**DEVIATION REQUEST
AND DECISION FORM**

Project Name :	Grandwood Ranch
Schedule No.(s) :	6119000003
Legal Description :	S2N2, EX PT TO HIGBY RD CONV BY REC# 205092691 W/MR SEC 19-11-66

Deviation Request No. 4

GRANDWOOD RANCH - FURROW ROAD DEVIATION REQUEST EXHIBIT

Deviation Exhibit 4

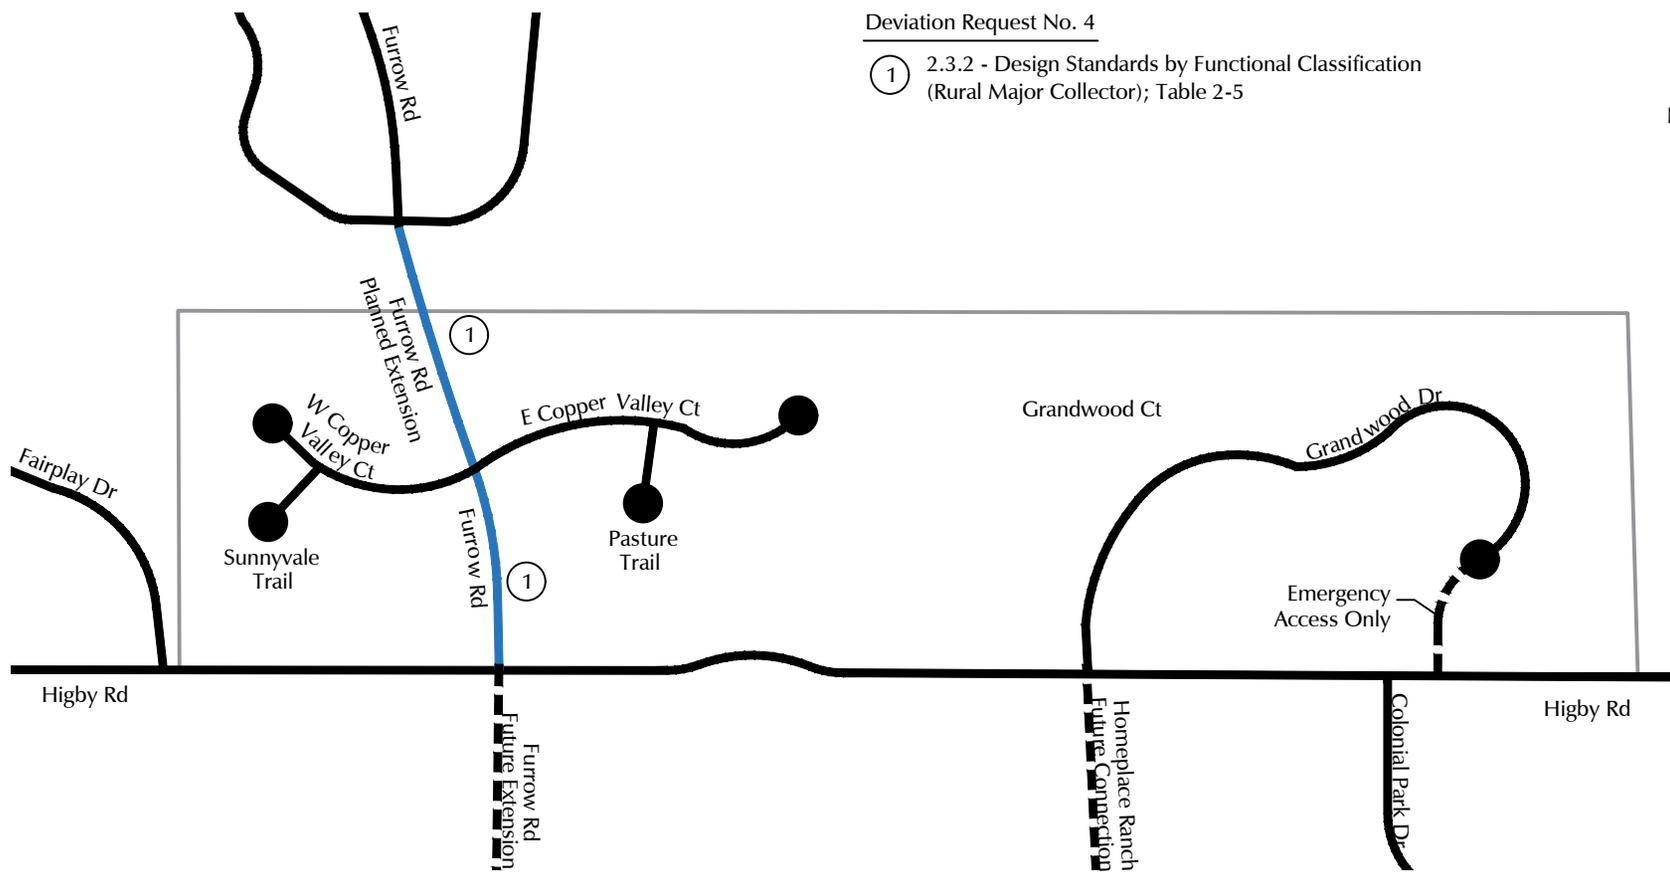
The following alternatives to Rural Major Collector standards are requested, per criteria in Table 2-5 of the ECM. Please refer to the LSC Exhibit No. 4 and the attached plan & profile exhibit by Matrix Design Group:

- Design speed on Furrow Road of 40 mph instead of 50 mph
- Posted speed limit on Furrow Road of 35 mph instead of 45 mph
- Minimum centerline curve radius of 600 feet instead of the prescribed 930 feet

**FURROW ROAD PROFILE
PROPOSED K-VALUES**

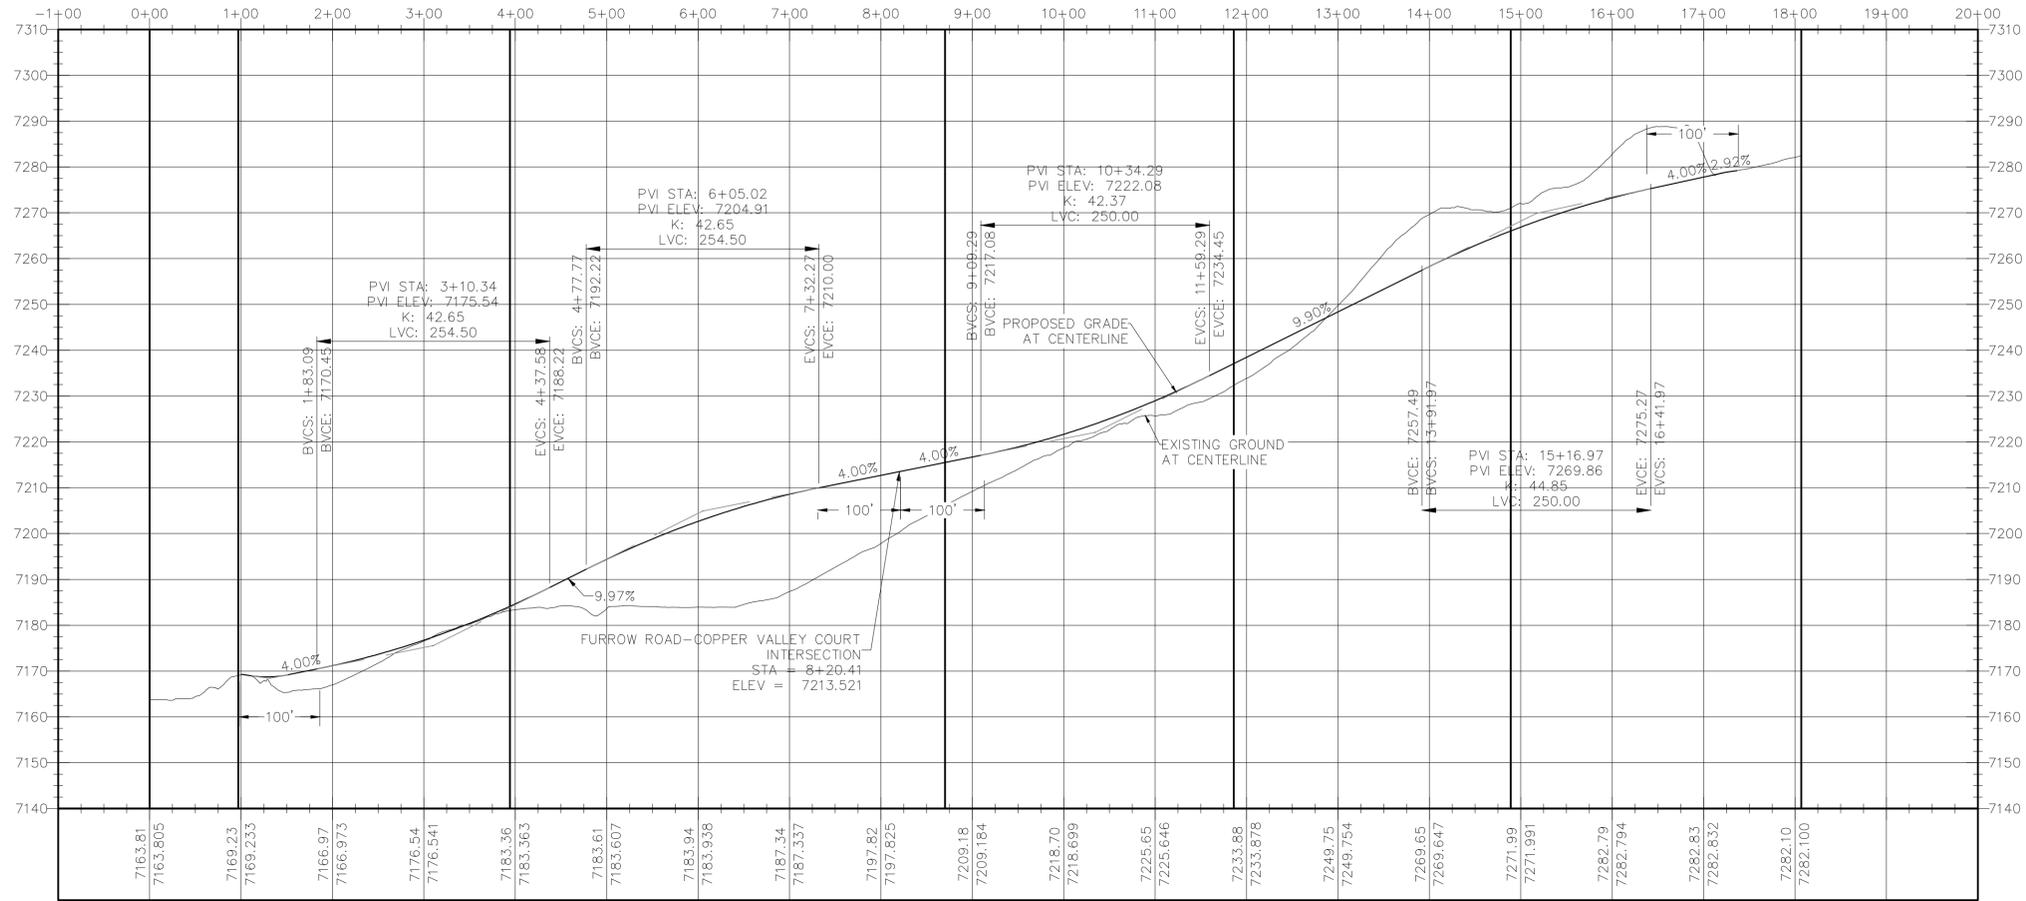
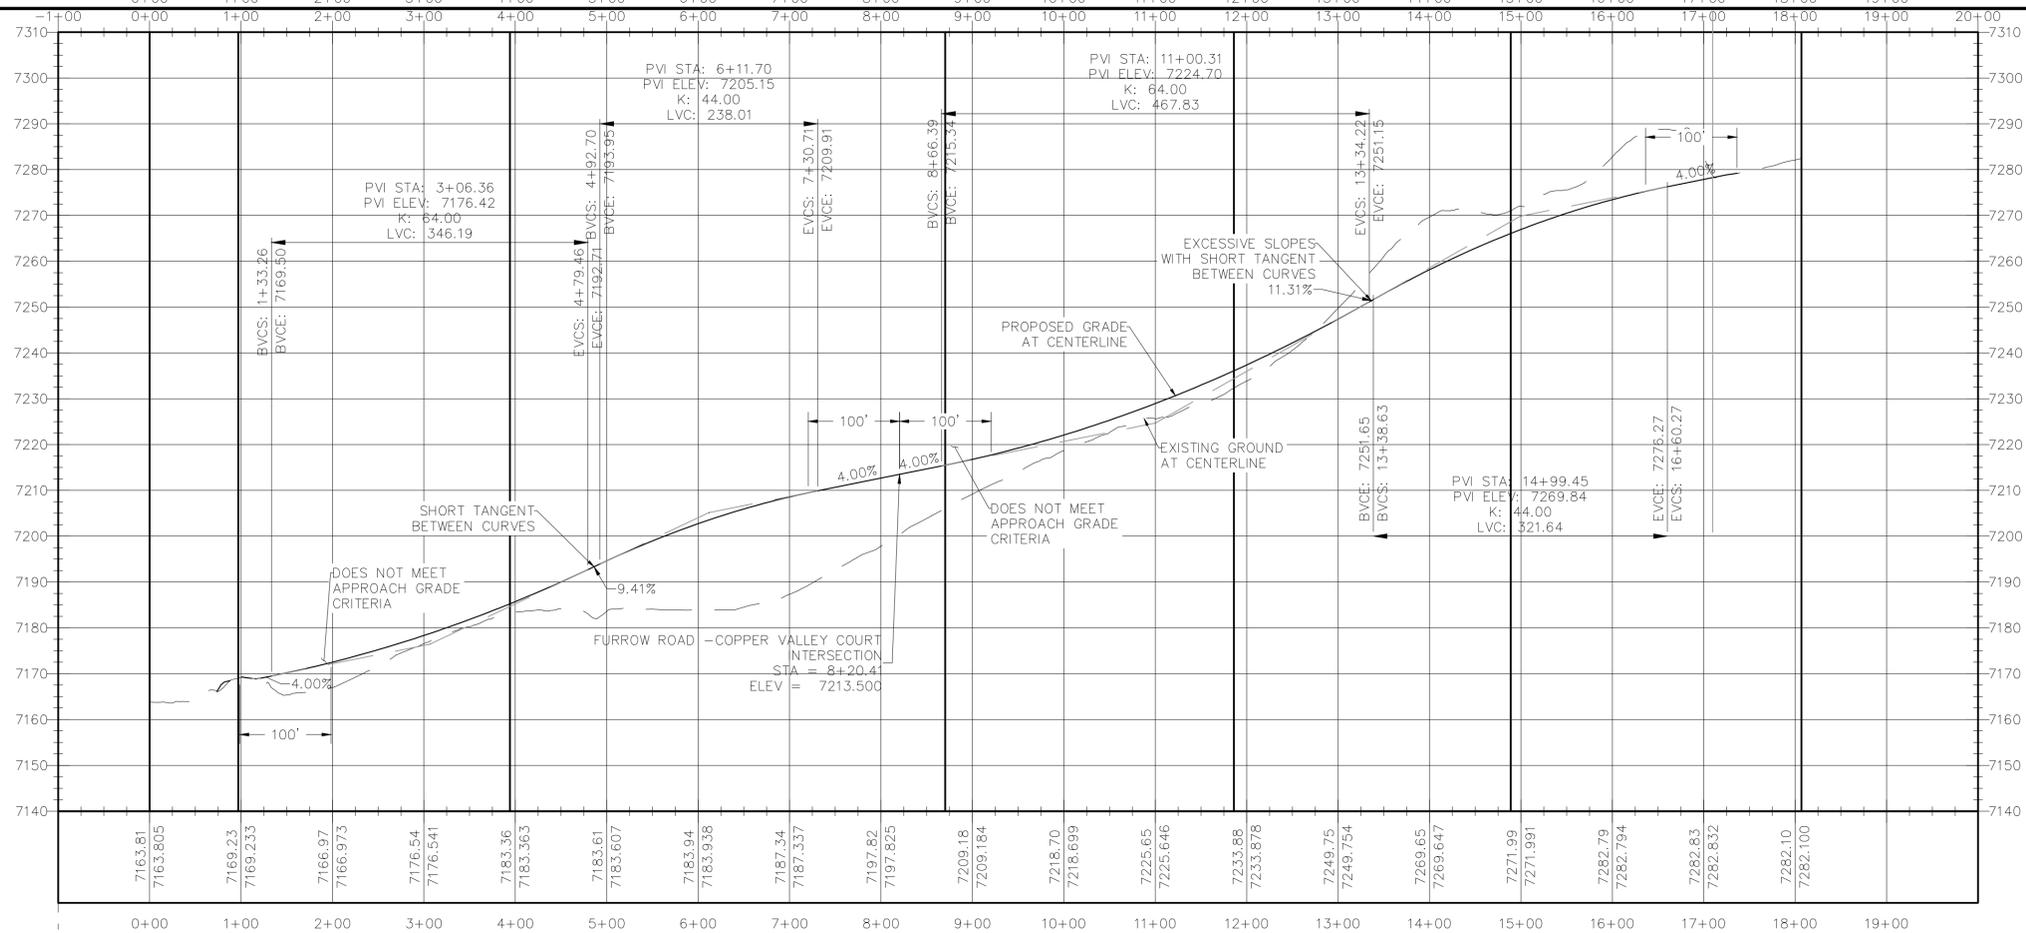
- Minimum K-value for a collector with a design speed of 40 mph is 44 for crest curves and 64 for sag curves. The proposed K-values for both crest and sag curves along Furrow Road is 42 with stop conditions at the intersection of Higby Road/Furrow Road and Furrow Road/Minglewood Trail.

- Existing conditions along the Furrow Road alignment show approximately 113-feet of vertical fall resulting in an average 7% slope. With El Paso County criteria of 4% approach grade for 100-feet and, at a design speed of 40 mph, a K-value of 44 for crest curves and 64 for sag curves, there is not enough horizontal room to allow the vertical design of Furrow Road to meet Criteria completely. The attached exhibits provide a visual of the proposed vertical design with the approved deviation and with attempts at meeting Criteria. Using K-values with the proposed Furrow Road results in short and steep tangent sections between curves that exceed maximum limits and does not allow for proper approach grades at intersections for the required distance.

FURROW ROAD - CURRENT PROPOSED IMPROVEMENTS GEOMETRY

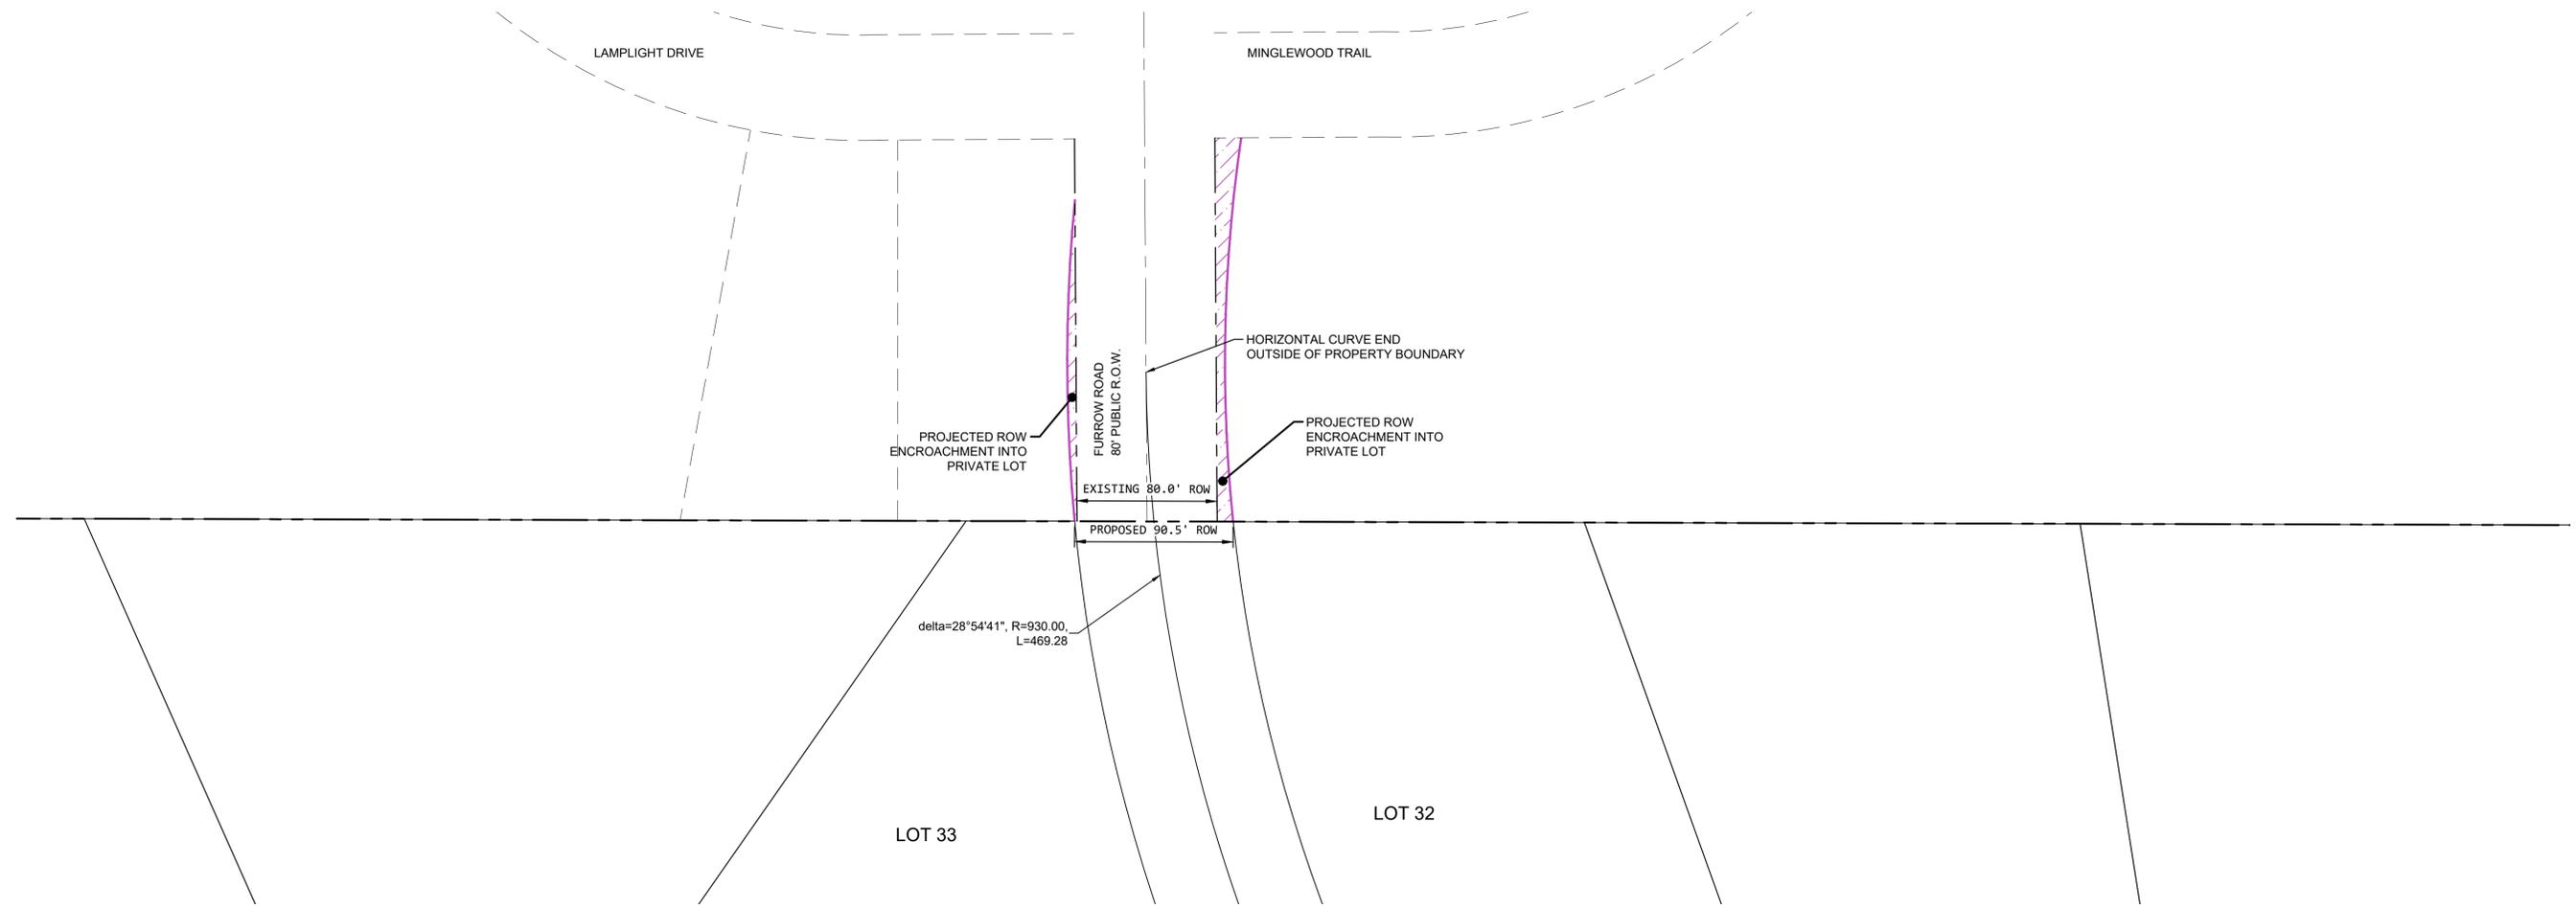
- If a horizontal curve radius of 930 feet were to be used (as required for a Major Collector), Furrow Road would have to shift west to incorporate the geometry. Shifting the roadway to create a larger radius would reduce lots west of Furrow Road below the 2.5-acre minimum lot size. This shift would also result in improvements encroaching into designated Preble mouse habitat on the west side of Furrow Road.

- Geometry previously shown with a 93-foot horizontal curve radius and 90-foot ROW resulted in public ROW encroaching into existing private lots within Timberview Subdivision. Please reference attached exhibit for further explanation on geometric constraints.
